Fort Calhoun Station
Unit No. 1

Title: CORE OPERATING LIMIT REPORT

Reason for Change: Increase allowable peak liner heat
rate in COLR from 14.4 kW/ft to
15.5 kW/ft until 7770 MWD/MTU.

Cycle 14 Core Operating Limits Report

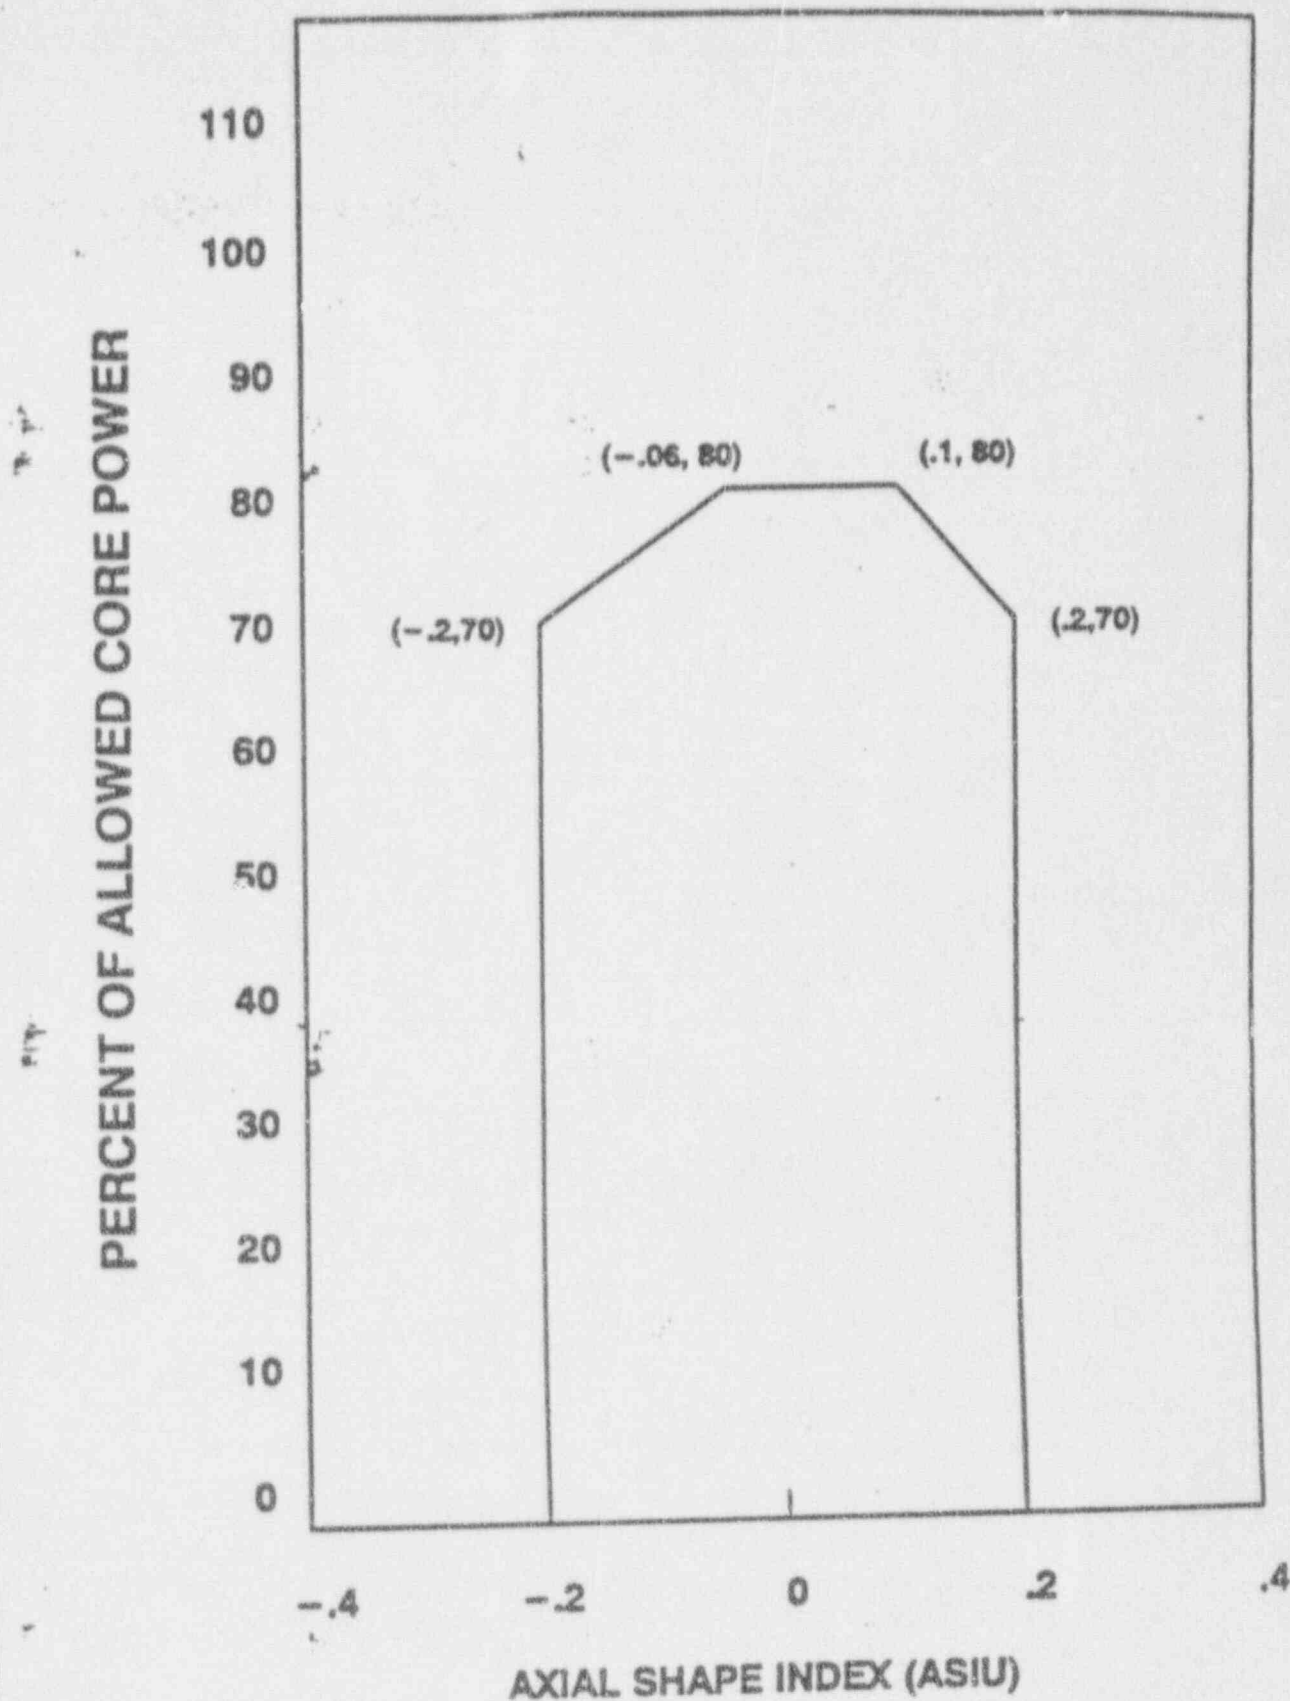
The allowable peak linear heat rate vs. burnup for Cycle 14 is 15.5 kW/ft for less than or equal to 7770 MWD/T, and 14.4 kW/ft for greater than 7770 MWD/T. The allowable peak linear heat rate for Cycle 14 is shown in Figure 3.
